UNITED STATES OF AMERICA
NUCLEAR REGULATORY COMMISSION

In the Matter of)
)
DUKE ENERGY FLORIDA, LLC) Docket Nos. 52-029 and 52-030
)
(Levy Nuclear Plant, Units 1 and 2))

NRC STAFF RESPONSES TO COMMISSION PRE-HEARING QUESTIONS

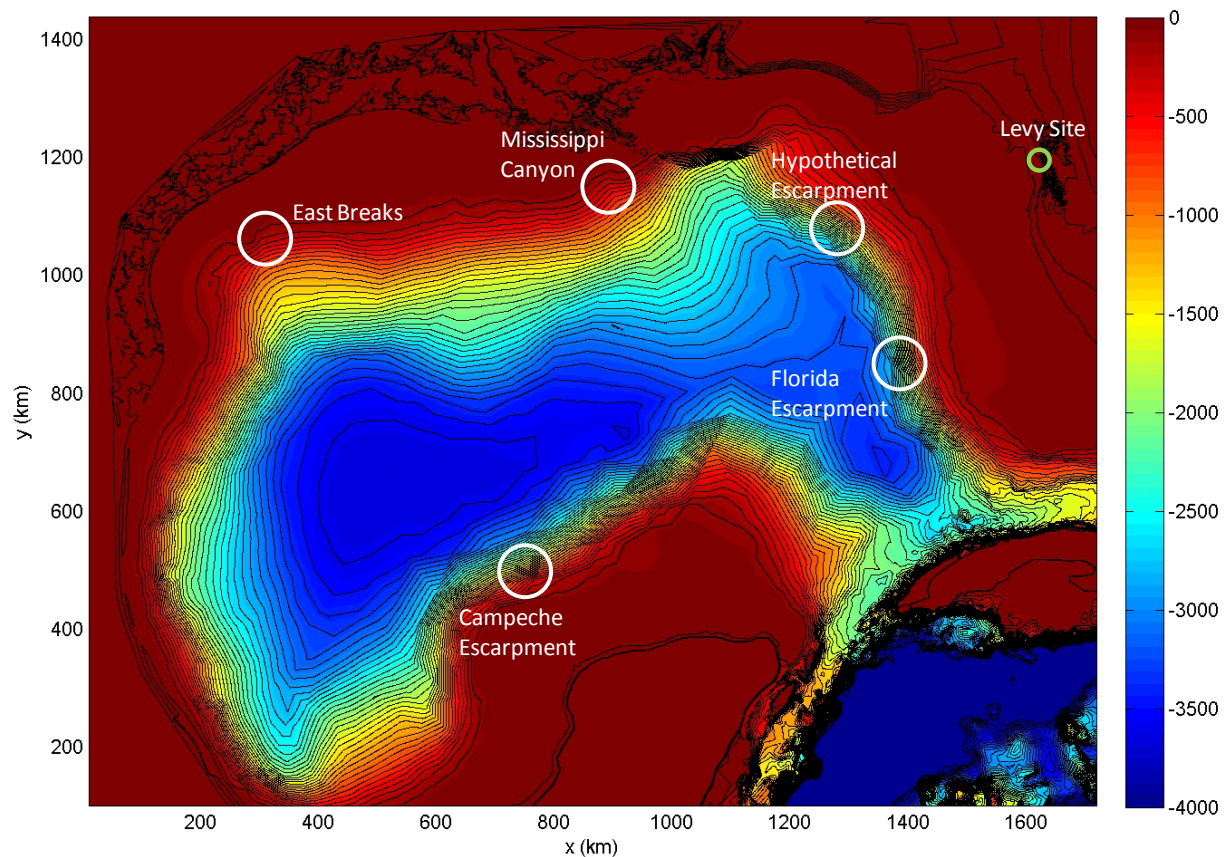
1. In its analysis of seismic seiches, the Safety Evaluation Report (SER) at 2-165 states: "Parameters for the maximum submarine landslide were determined for each of the provinces, except for the Campeche Escarpments where we are awaiting additional data."

New escarpment studies have recently been released (e.g., Monterey Bay Aquarium Research Institute, 2013) that map the escarpment in considerably more detail than studies that are reflected in SER Section 2.4. Did the Staff consider the more recent studies and their possible effect on the conclusions in the SER? If so what were the results?

Staff Response: The Staff did not consider the more recent studies referenced in the question. However, the Staff is confident that results from the 2013 multibeam mapping of the Campeche Escarpment have no effect on the conclusions in the SER. This is because the Staff used a very conservative independent tsunami hazard analysis to verify the applicant's probable maximum tsunami results. Since the data needed to develop a realistic estimate of the landslide parameters for the Campeche Escarpment were not available, the Staff developed very conservative estimates of the maximum-potential submarine landslide for the Campeche Escarpment. Specifically, the Staff performed one-dimensional numerical model simulations using a provisional tsunami landslide source located at the Campeche Escarpment to estimate the resulting potential for flooding at the Levy Nuclear Plant (LNP) site. Initial conditions for the landslide source were based on maximum observed landslide parameters along the Florida Escarpment, which is a similar geologic environment. The Staff's analysis for the Campeche source computed the wave runup to stop after progressing 0.6 miles inland. Since the LNP site is 9.6 miles inland, the maximum extent of the tsunami wave does not come within 9 miles of the site.

Similar one-dimensional numerical model simulations were performed for all the potential tsunami sources for the LNP site (See Figure 1). The model simulations employed by the Staff were conservative because they did not account for the radial spreading of the wave and did not account for friction. This approach resulted in conservative estimates of the size and runup of the wave. These model simulations confirmed the applicant's conclusion that the Mississippi Canyon source has the greatest potential to bring the large tsunami wave to the Levy site and was appropriately designated as the probable maximum tsunami source.

The Staff then conducted independent confirmatory two-dimensional model simulations for the Mississippi Canyon. The Staff's tsunami model simulations employed modeling assumptions that included additional conservativisms not included in the applicant's model, such as assuming that the entire submarine landside volume 'slumps' instantaneously and into a large mass on the seafloor. The Staff's model produced results that showed the probable maximum

tsunami estimated by the Staff (20 ft) or the applicant (12.94 ft) would not reach the LNP site (site grade of 51 ft).
